PATENT APPLICATION
Docket No. 02-C-106

REMARKS

IN THE DRAWINGS:

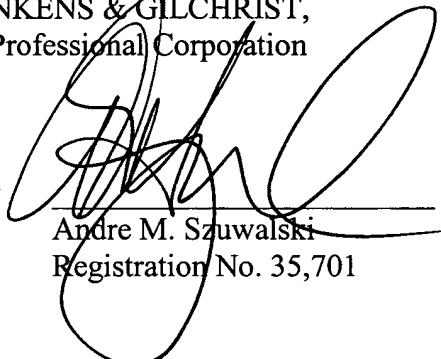
Please amend Figure 2 of the Drawings as shown attached hereto. The proposed amendment adds a connection dot at the drain of transistor 27 and connects the Mout signal line to the drain of transistor 29. These changes are fully supported by the specification as originally filed and no new matter has been added.

Concurrently filed herewith please find a replacement drawing sheet reflecting the changes.
